**Ordinance Number: 1365-23, File Number: 19-24**

**RTA Tunnel Membrane Replacement- Addendum 3**

**NARRATIVE:** Addendum 3 contains the following:

Designed: MSI	Drawn: MSI	Checked: LGW	Approved: LGW
Scale: AS SHOWN		Project No.: 198348	
Date: FEBRUARY 2024		Sheet: C-6

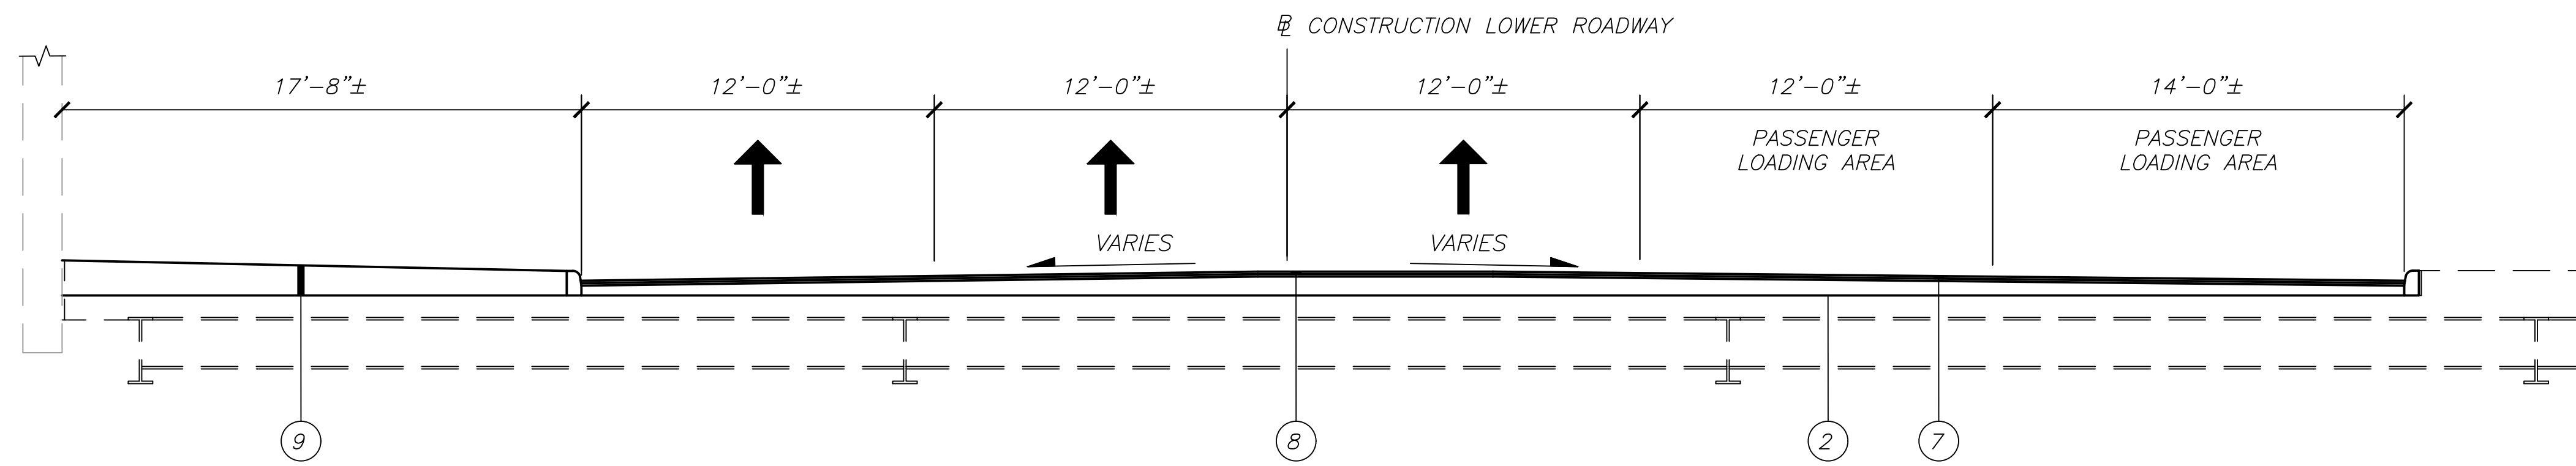
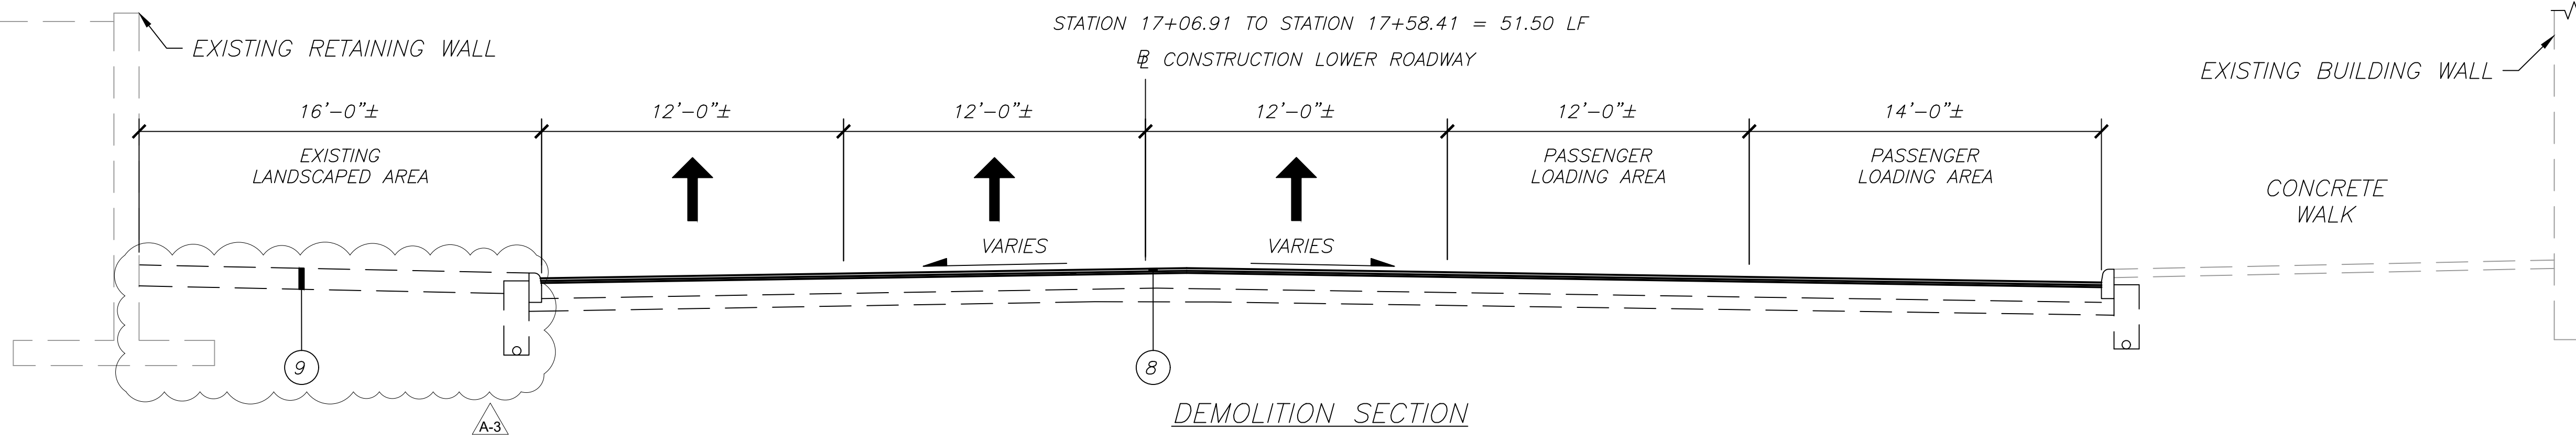
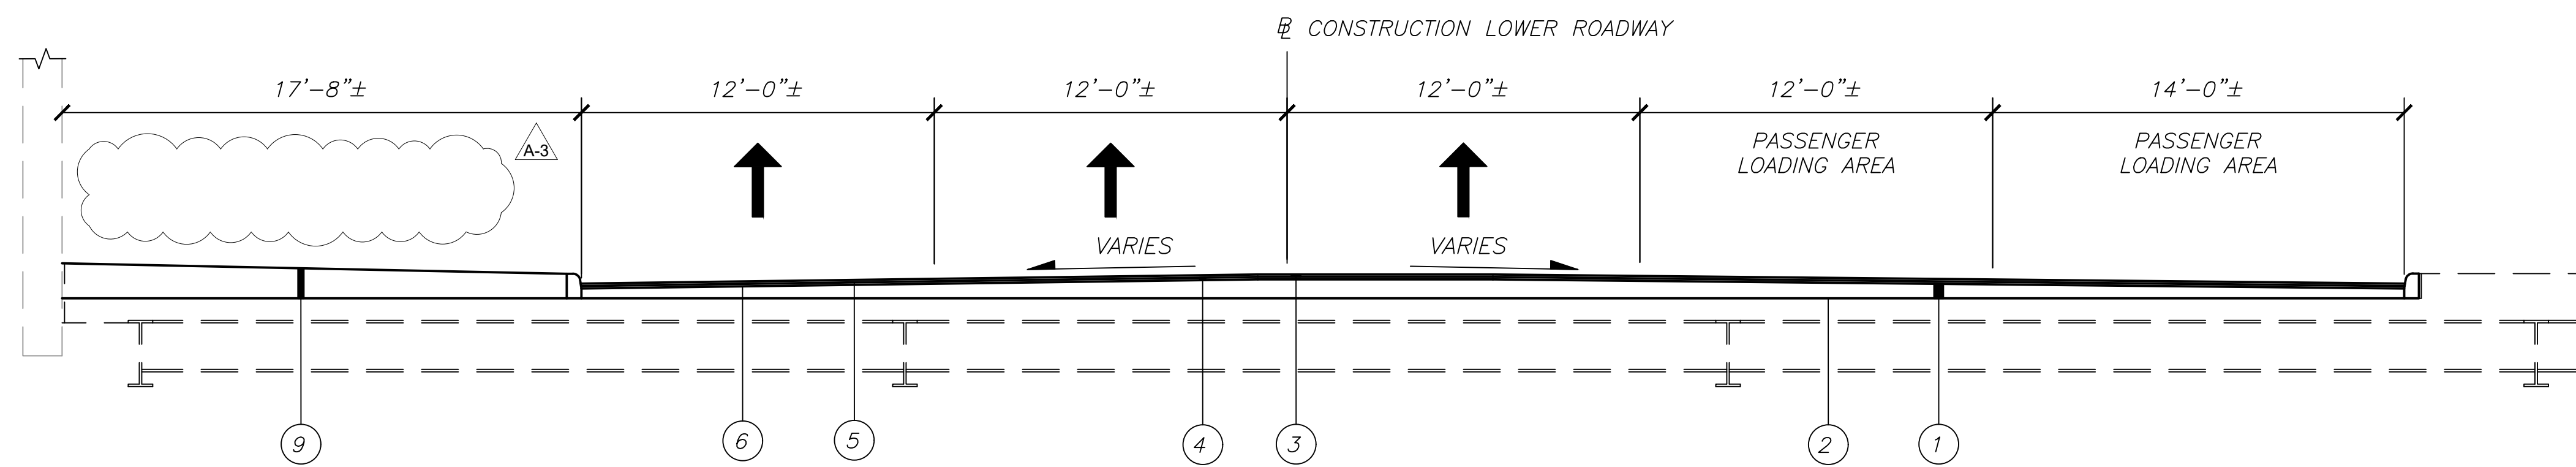
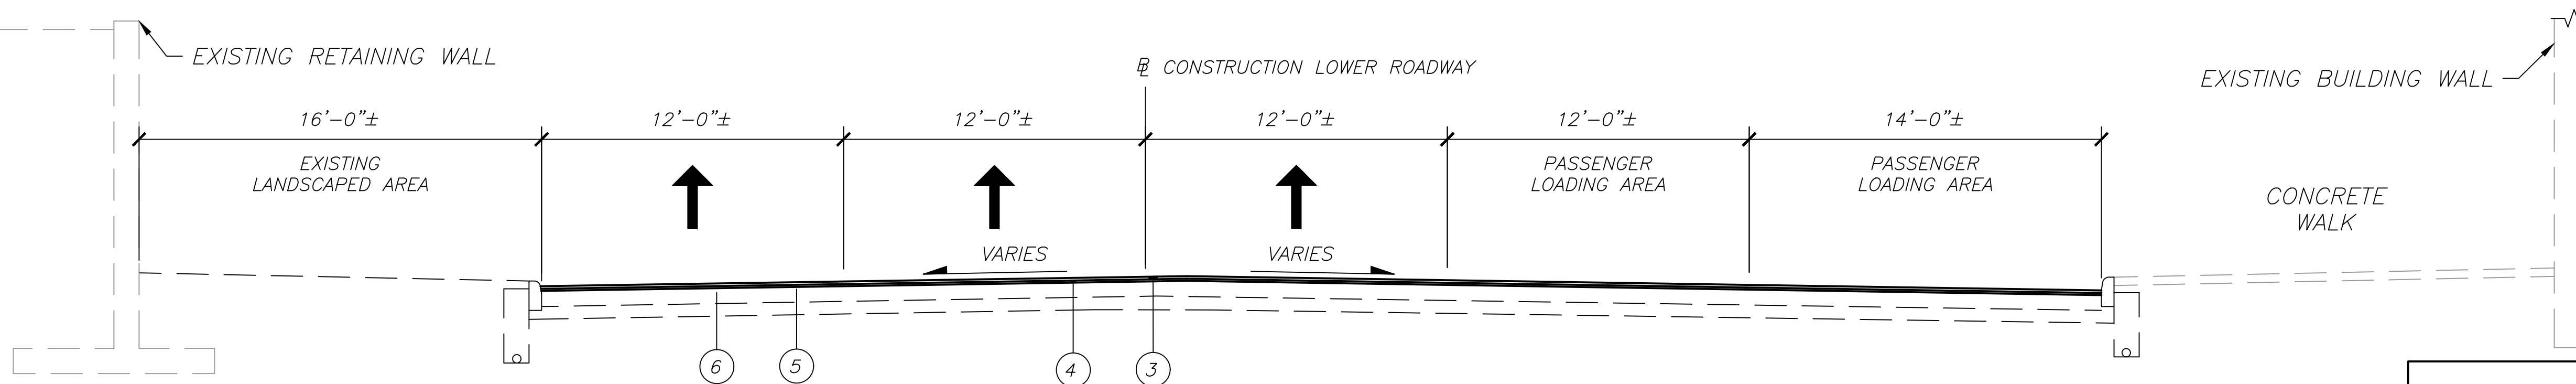
- 1) Sheet C-2: Sheet Index and the Summary of Quantities have been updated.
- 2) General Notes on Sheet C-3 have been updated.
- 3) Typical Sections were revised on Sheet C-6.
- 4) Sheet C-7 Revised to show new sidewalk replacement limits.
- 5) Notes were revised on Sheet C-8.
- 6) Barricade with Fence Detail added to Sheets C-10 and C-11.
- 7) Sheet C-11 revised to show new limits of Phase 2.
- 8) Sheet C-12 has been deleted.
- 9) Sheet C-13 is being reissued to add Phase 4 to install pavement markings following the 30-day cure period.
- 10) Sheet C-14 is being reissued in its entirety to show changes in project phasing.
- 11) Sheet C-15 is being reissued in its entirety due to changes in phasing and waterproofing information.
- 12) Foam flashing detail has been removed from Sheet C-17.

Question: Proposed Typical Section on Plan Sheet C-6 details 10" concrete walk removed and reconstructed from Station 17+06.91 to Station 17+58.41 = 51.50 LF. However Plan Sheet C-7 shows begin sidewalk replacement at STA 16+72.65 and ending at STA 17+89.24. Please clarify.

Project Title			
RTA TUNNEL MEMBRANE REPLACEMENT			
Sheet Title			
DRAINAGE DETAILS			
Designed:	Drawn:	Checked:	Approved:
MSI	MSI	LGW	LGW
Scale:		Project No.:	
AS SHOWN		198348	
Date:		Sheet:	
FEBRUARY 2024		C-9

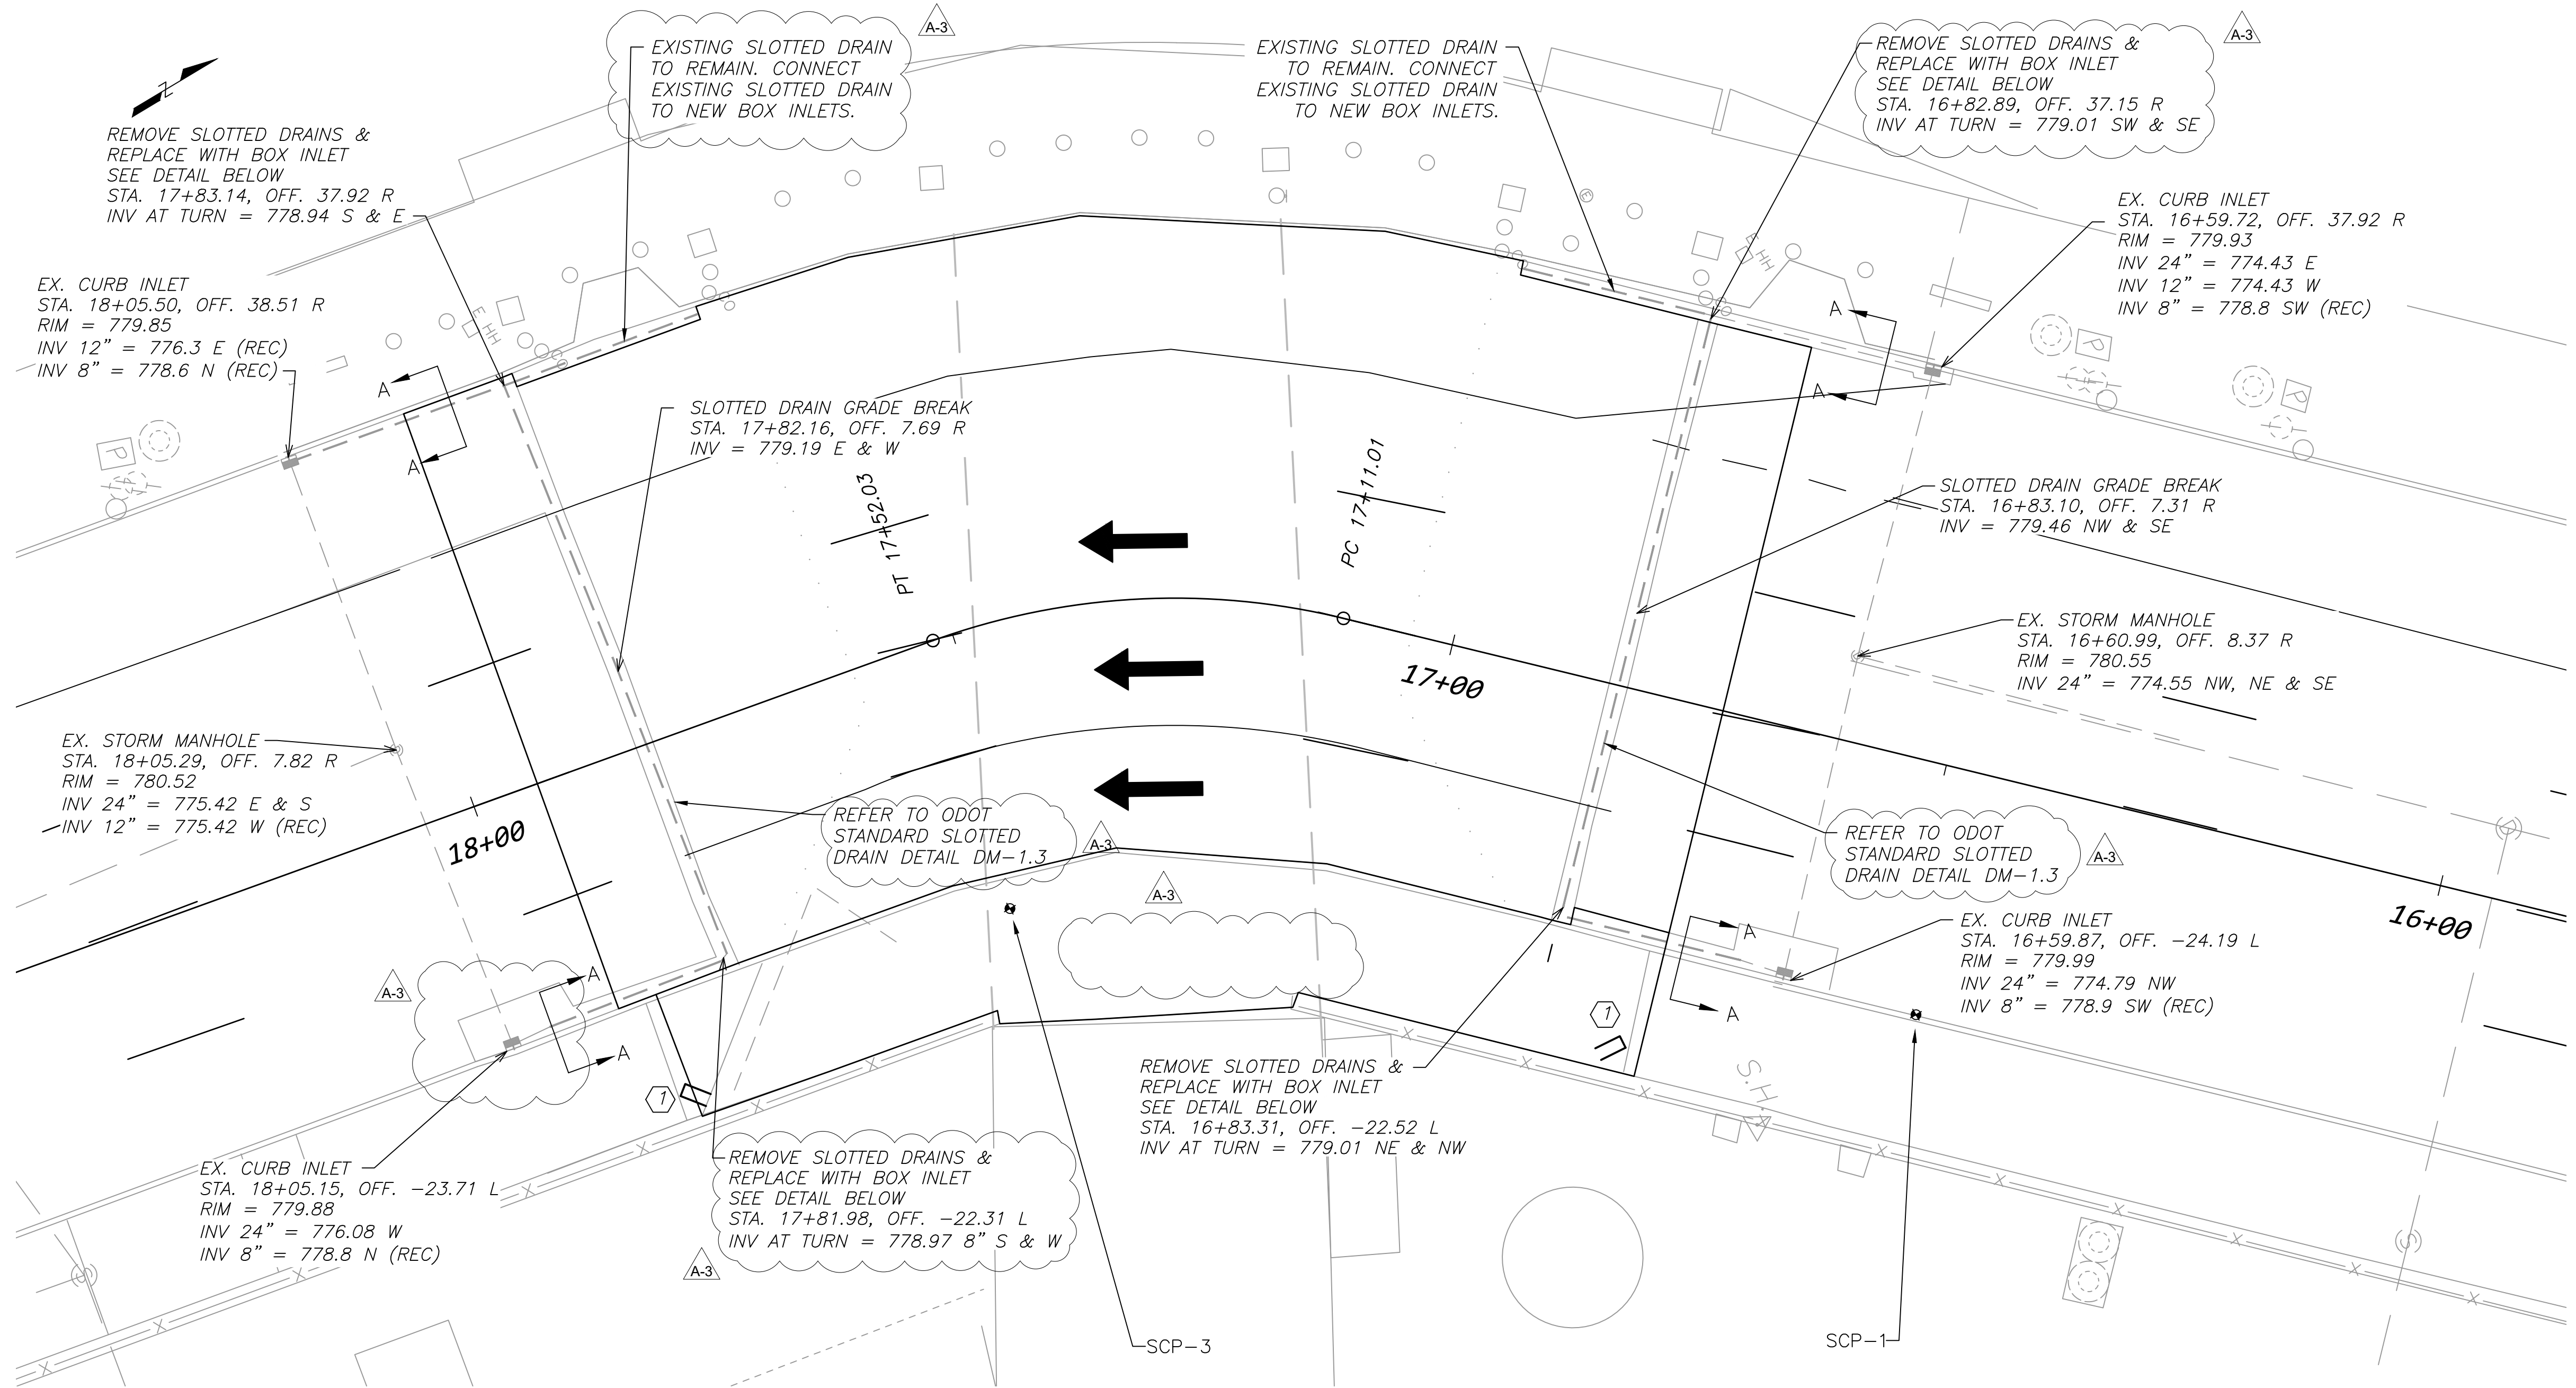
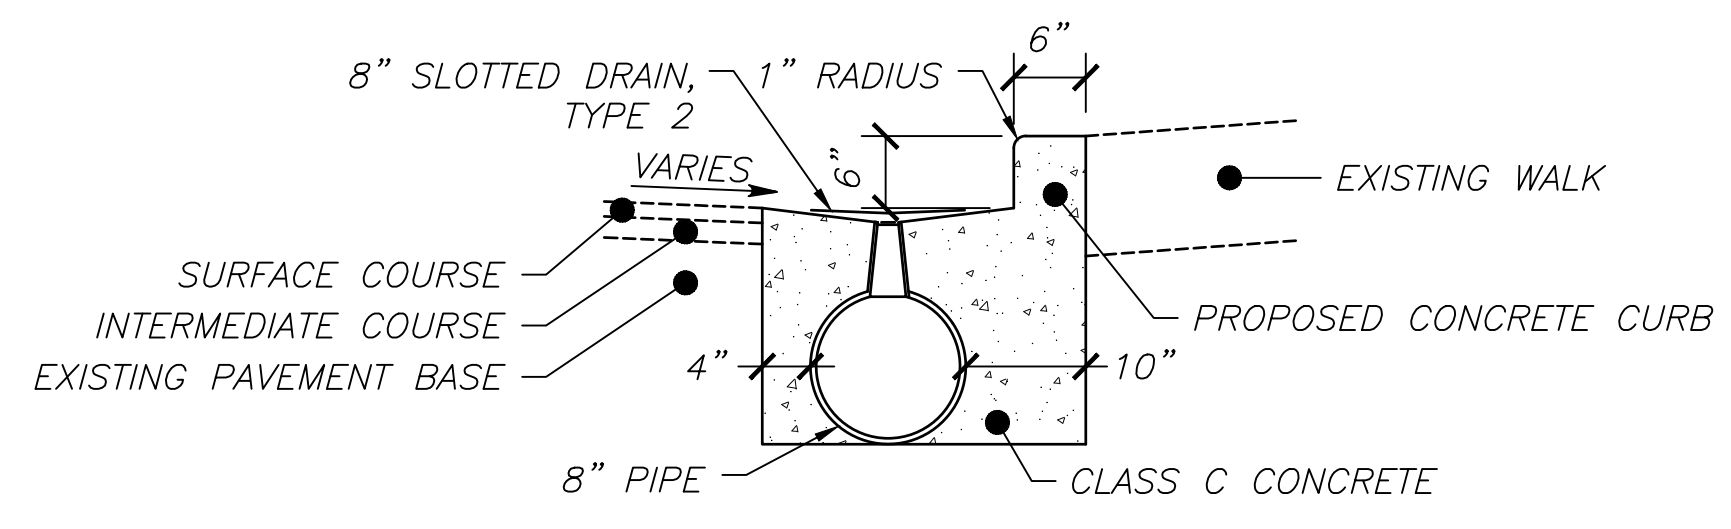
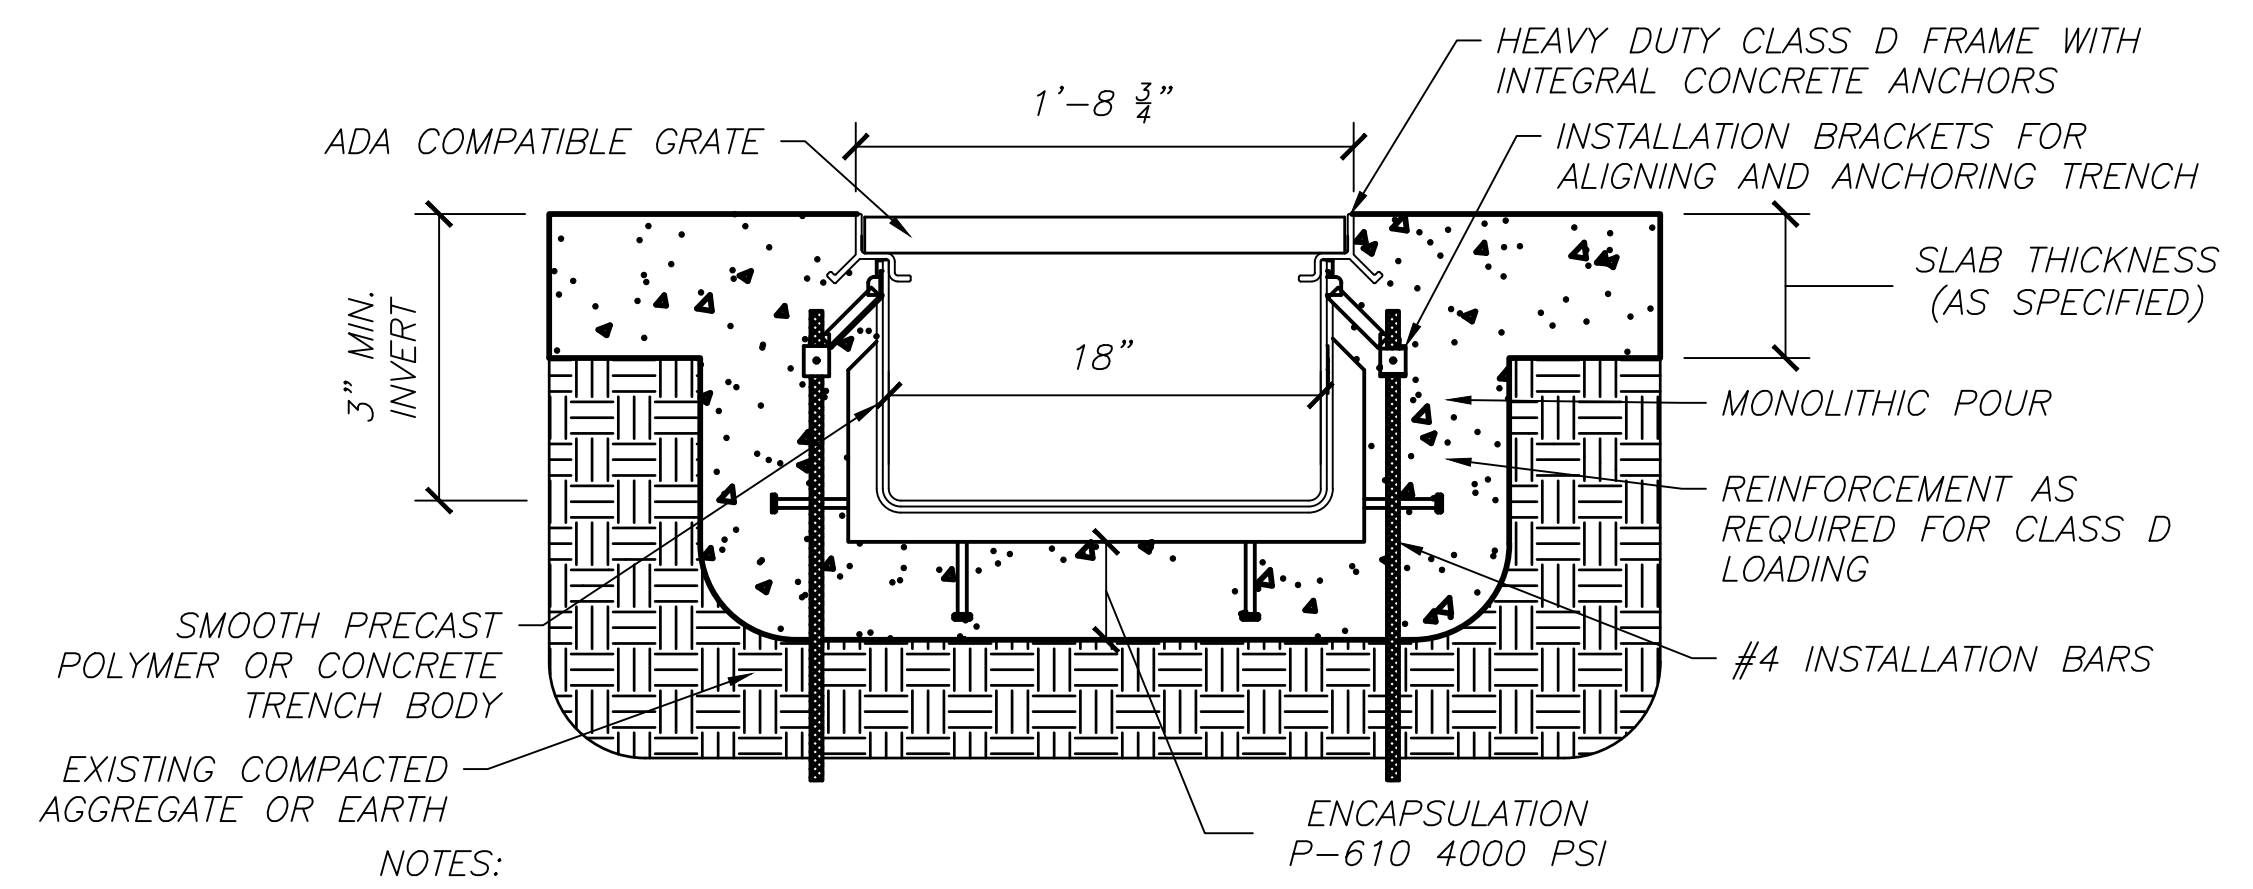
- THE EXISTING SLOT DRAIN WILL BE REMOVED AND REPLACED WITH BOX INLETS.
- SEE OHIO DOT STANDARD DRAWING DM-1.3 FOR SLOT DRAIN TYPICAL SECTION
- STANDARD SLOPE IS 0.5% UNLESS OTHERWISE SPECIFIED
- REINFORCE ACCORDING TO STRUCTURAL REQUIREMENTS FOR CLASS D LOADING
- TRENCH DRAIN MUST BE 1/8" BELOW FINISHED CONCRETE GRADE
